PLANNING, ZONING, & BUILDING DEPARTMENT
PZ&B Staff Combination Memorandum: Architectural Commission and Town Council

SUBJECT: ARC-24-0109 (ZON-24-0062) 1739 S OCEAN BLVD (COMBO)

MEETING: FEBRUARY 26, 2025, ARCOM
MARCH 5, 2025, TC

PROPOSED FRONT GATE PERSPECTIVE

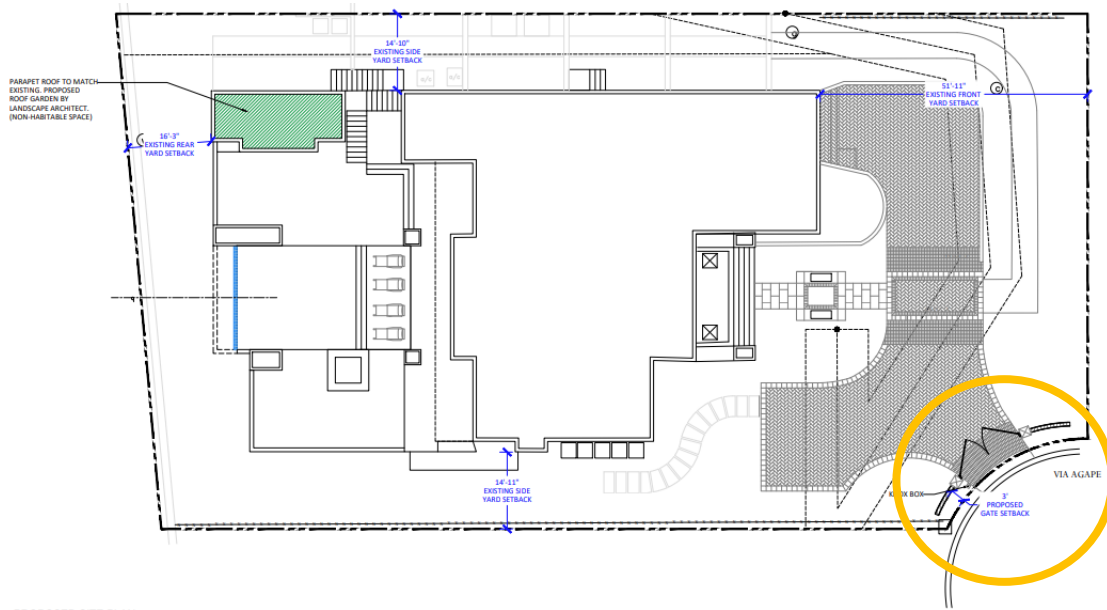
The vehicular gate is 13'-10" wide and set back 3'-0" from the front property line instead of the required 18'-0". Since the subject property is located on a cul-de-sac this deviation requires a special exception from Town Council. There are currently no other vehicular gates on this street.

Code Section	Required	Proposed	Exception
Special exception: Sec. 134-1668.	Minimum 18'-0" from street pavement.	3'-0"	15'-0"
